## Architect's Supplemental Instructions

**PROJECT:** *(name and address)*  
17-13 OSU College of Med. at Hastings  
Tahlequah, OK

**ASI INFORMATION:**  
ASI Number: Bid Pack 03 - ASI 01  
Date: 4/22/19

**Bid Package 03- ASI 01 – OSU College of Osteopathic Medicine At The Cherokee Nation**

SHEET NUMBER:  
**S1.12**

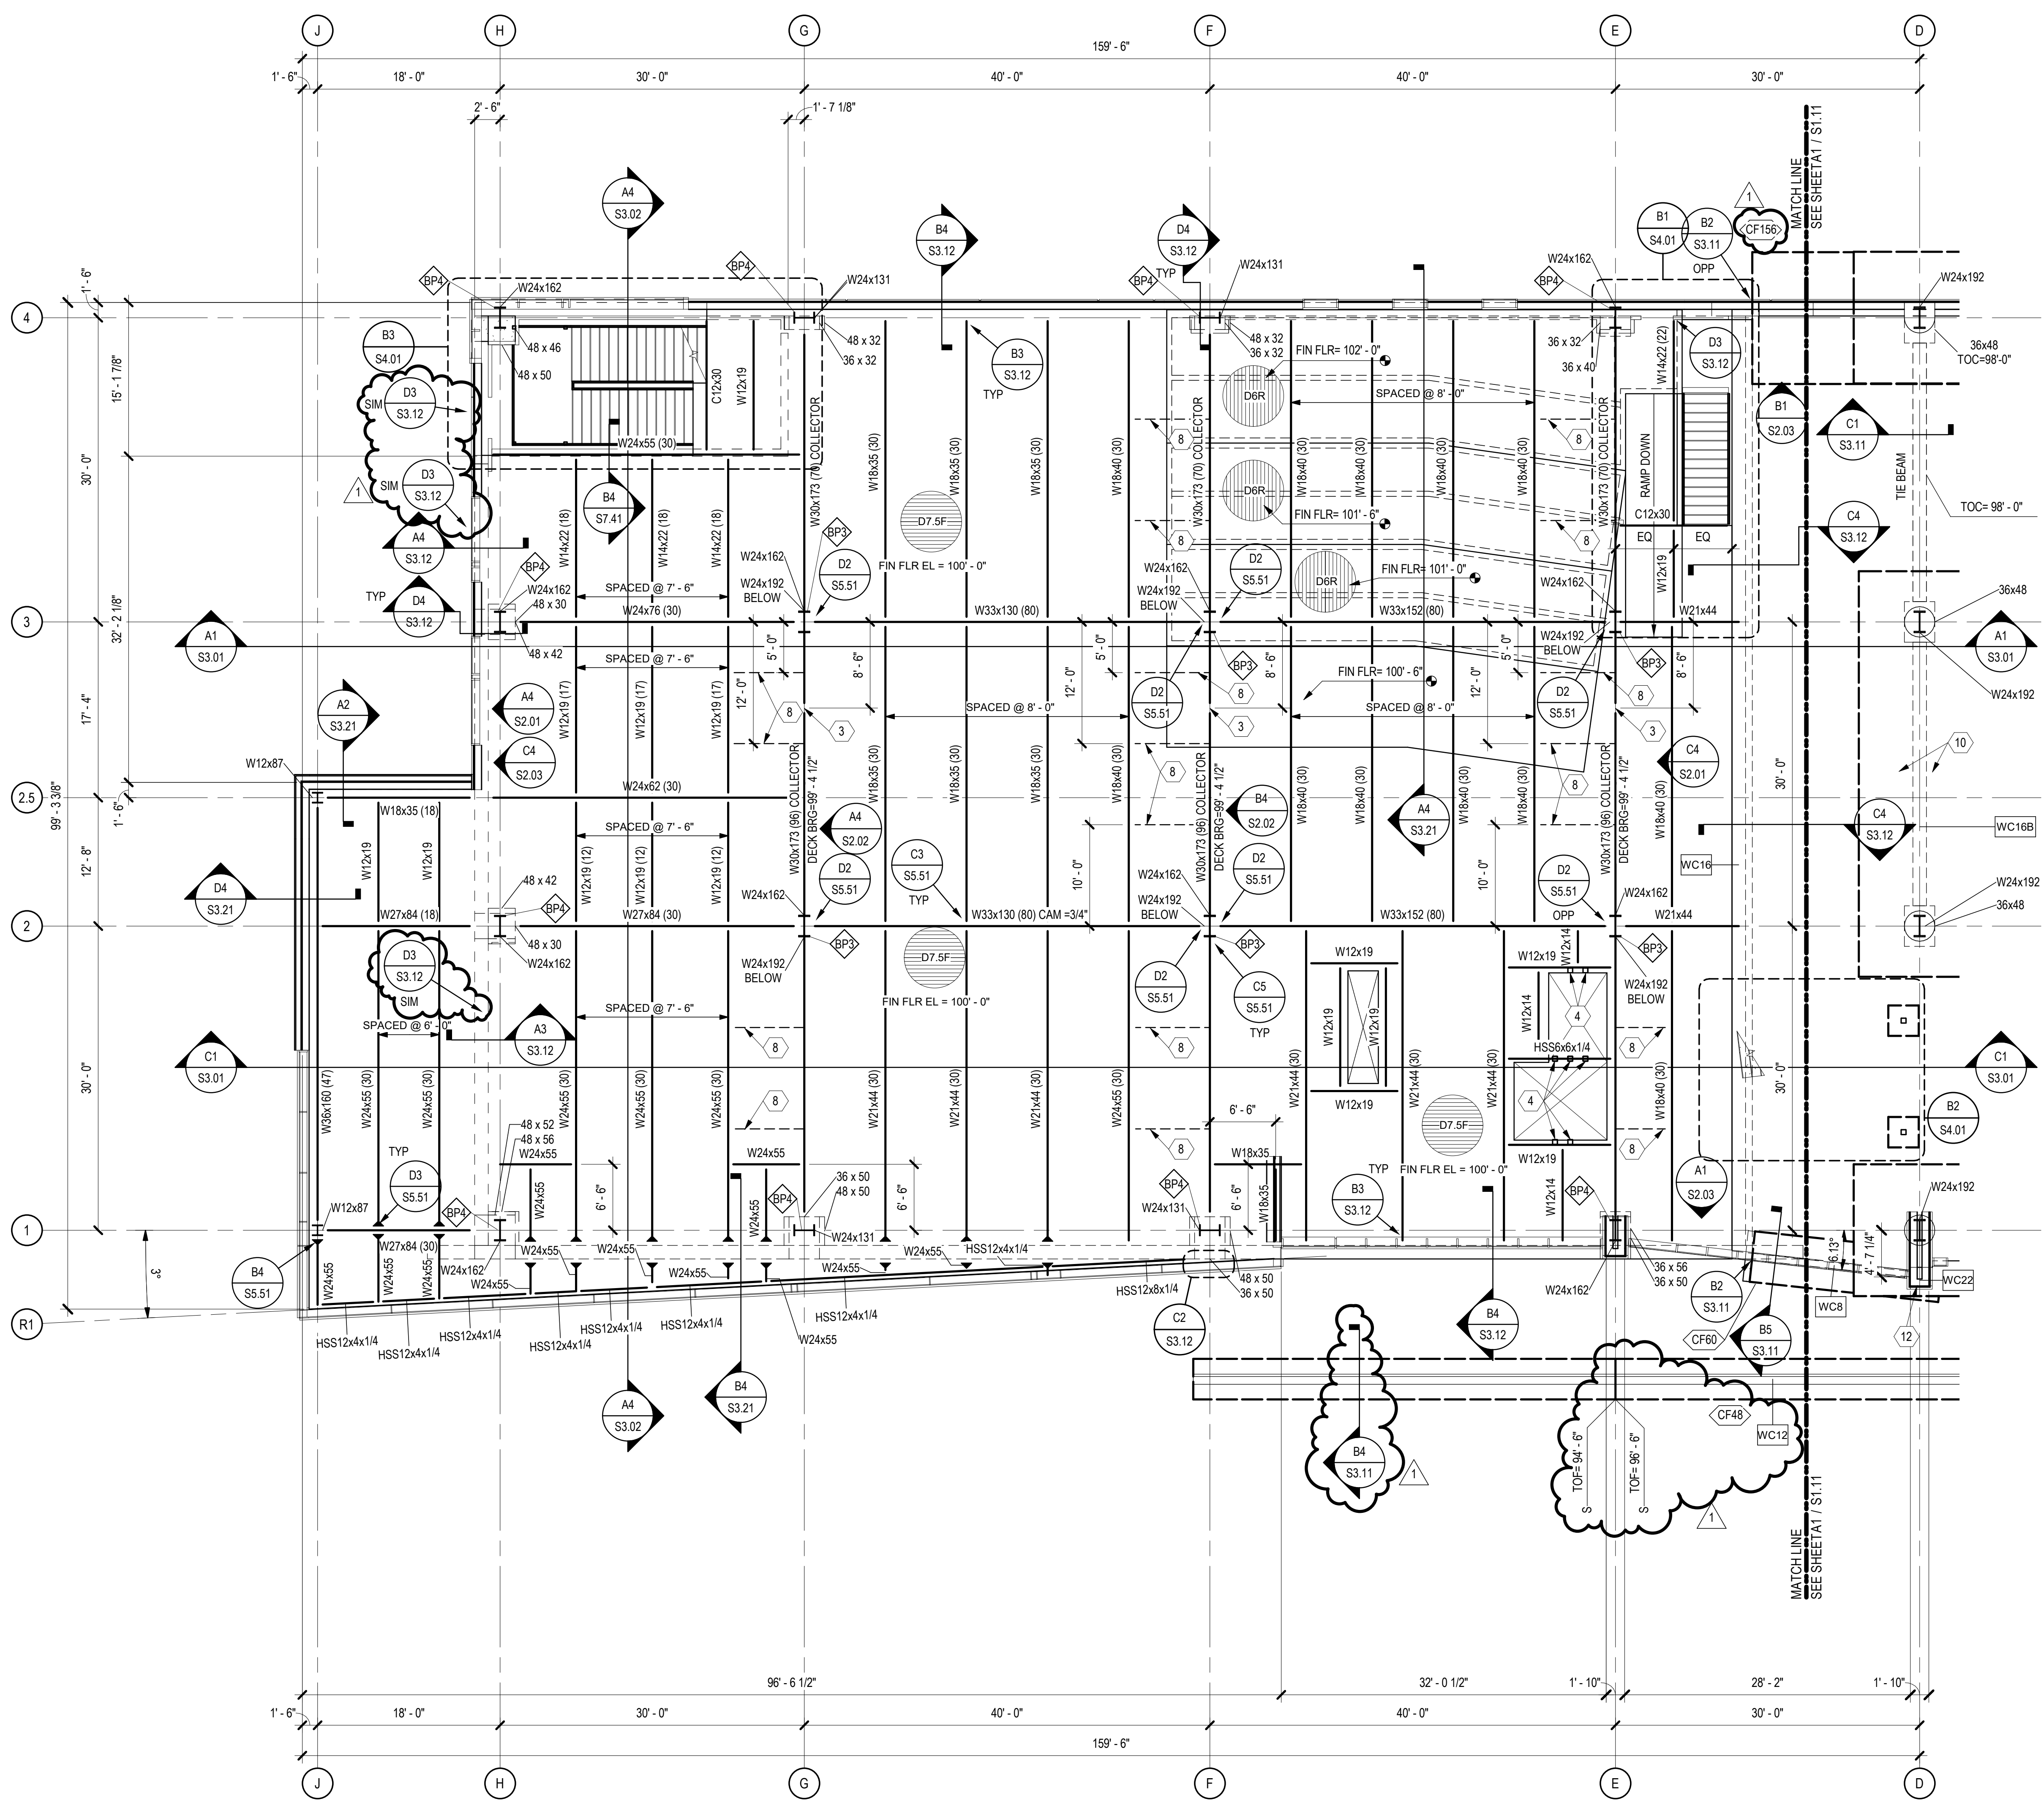
S1.11	Stud wall support clarification added at Grid D-1.
S1.12	Clarifying site wall information added along east side of building, near Grid 1.
S1.12	Detail D3/S3.12 (SIM) added along Grid H in three instances.
